CITY OF ALBUQUERQUE

June 11, 2021

**RE: Hiland Plaza
500 Central Ave. SE
Conceptual Grading and Drainage Plan
Engineer's Stamp Date: 06/01/21
Hydrology File: K17D120**

A1 EXISTING DRAINAGE PLAN
SCALE: 1" = 20'-0"

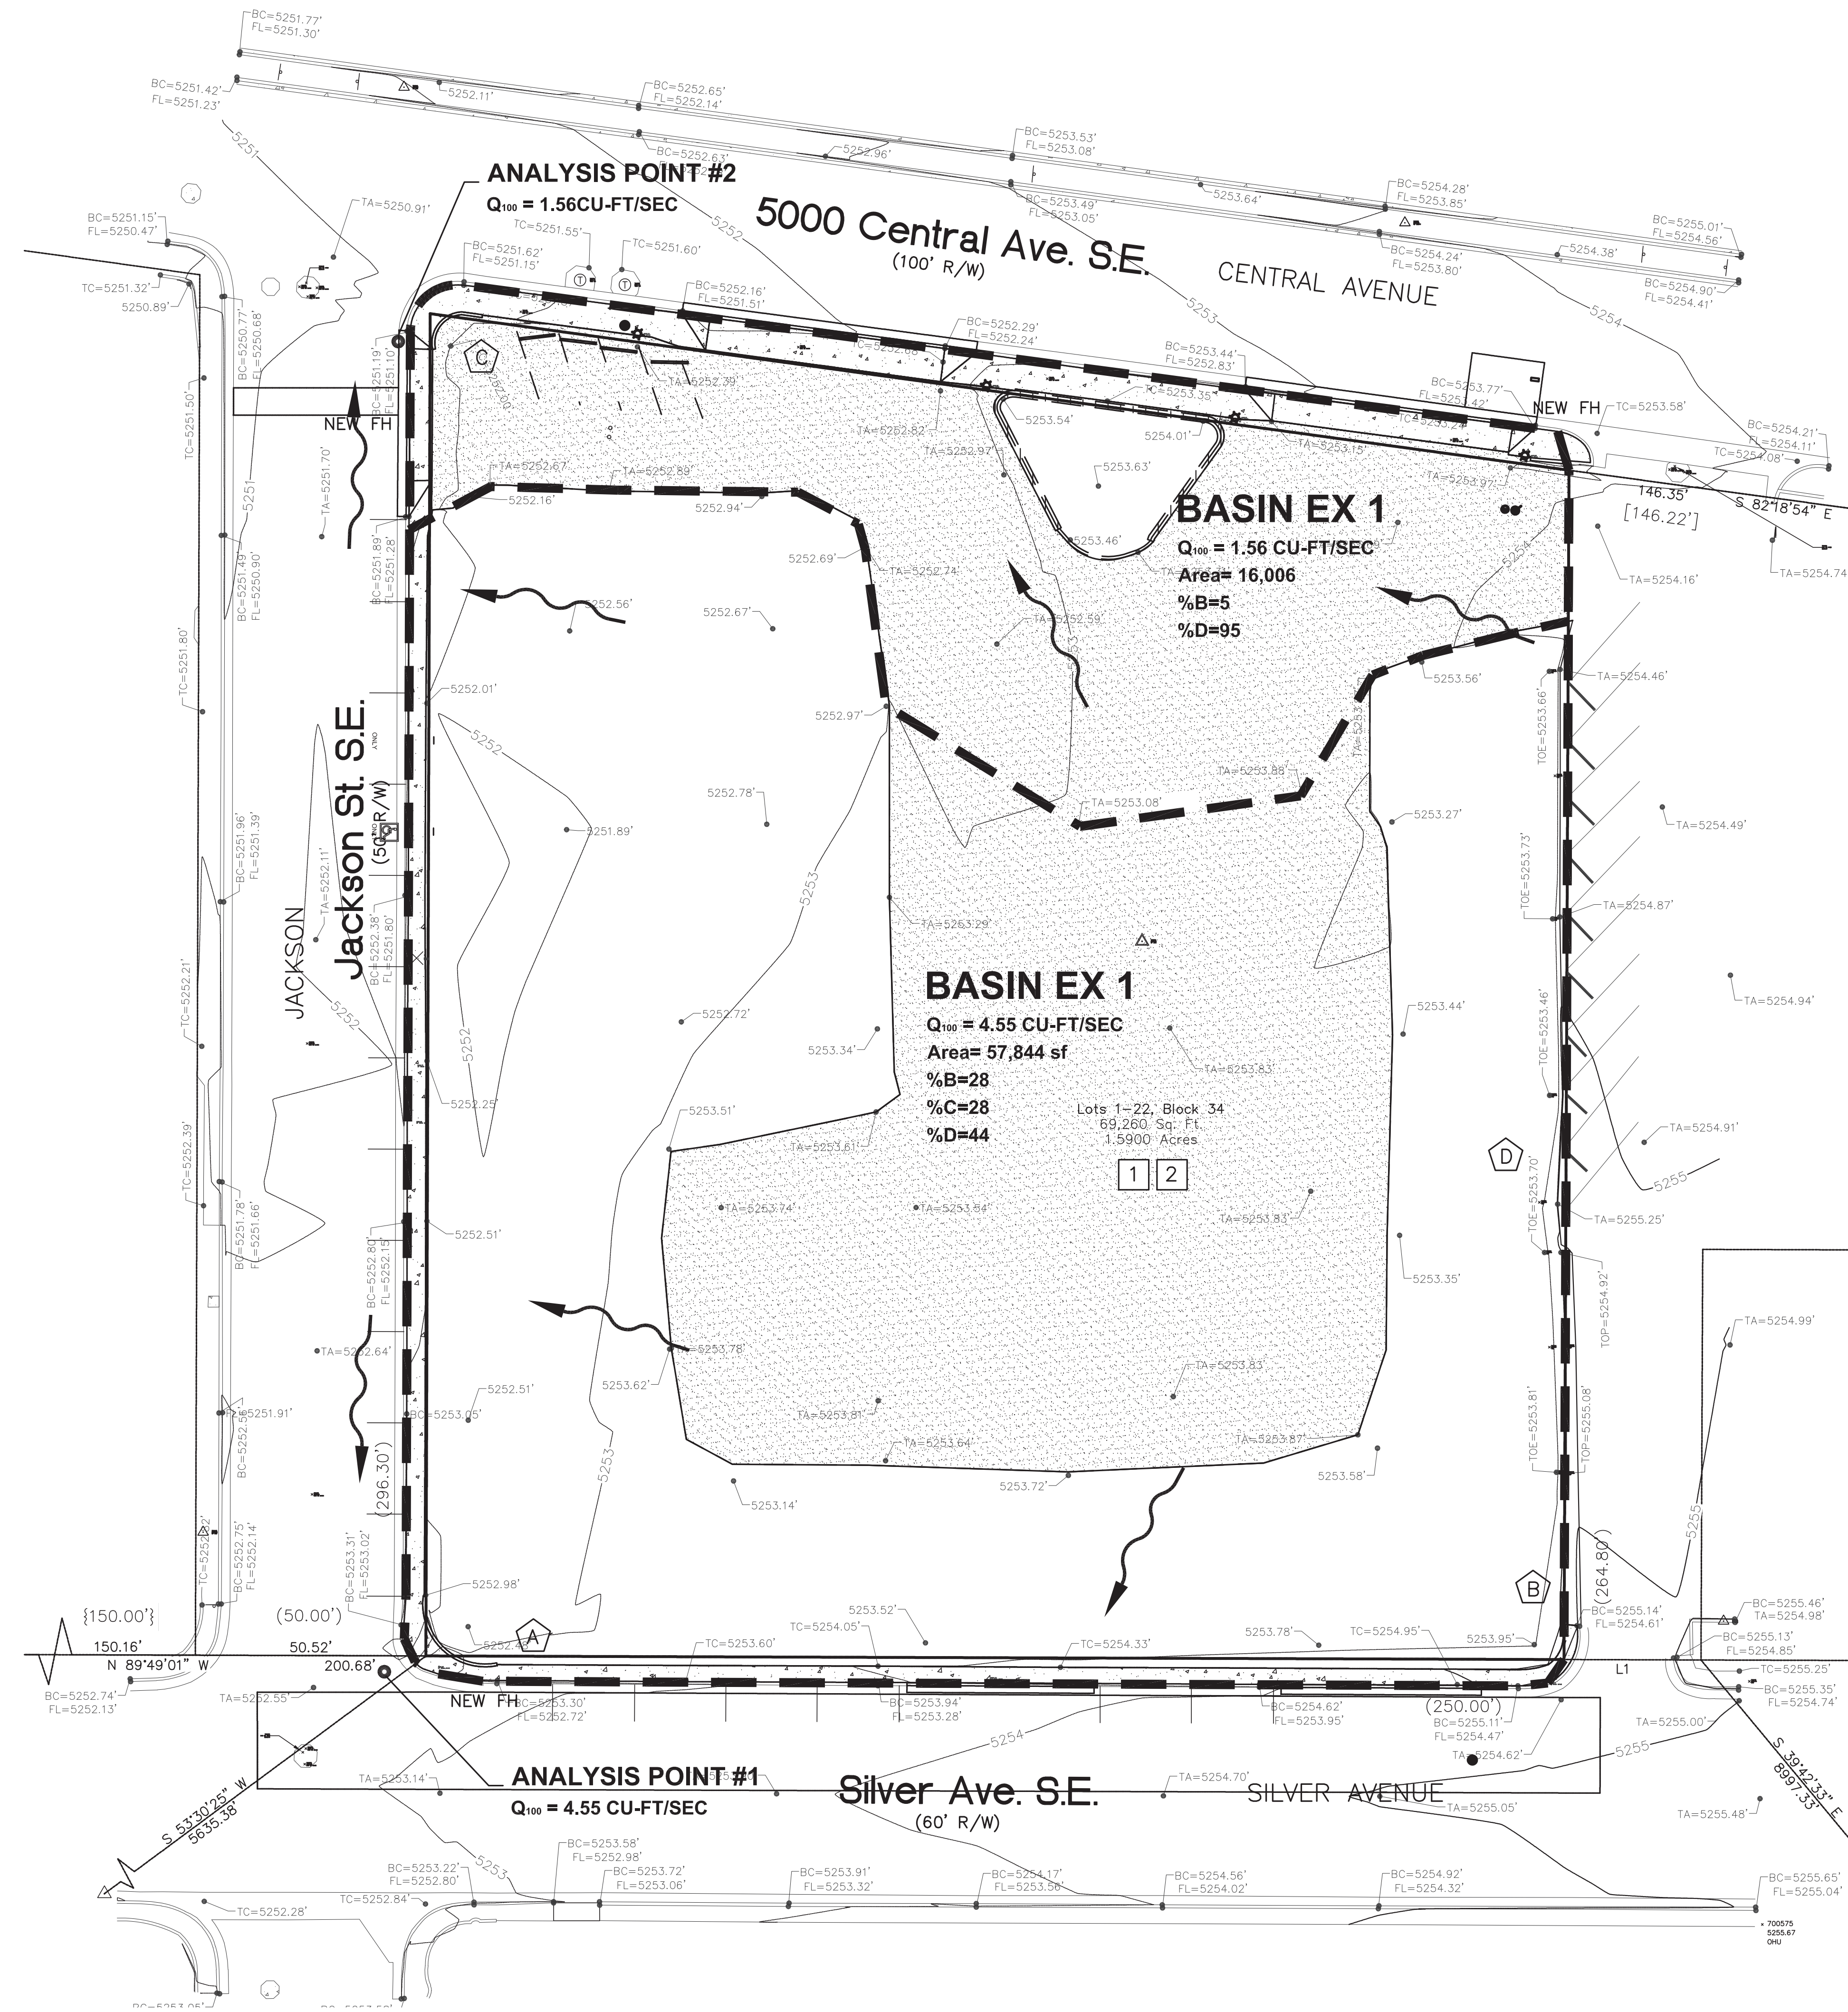
City of Albuquerque
Planning Department
Development Review Services
PRELIMINARY APPROVED
DATE: 06/11/21
BY: *Randy J. Gonzalez*
K17D120

THIS PLAN AND/OR REPORT ARE
CONCEPTUAL ONLY. MORE INFORMATION MAY
BE NEEDED TO THEM AND IS LIMITED TO
HYDROLOGY FOR BUILDING PERMIT APPROVAL.
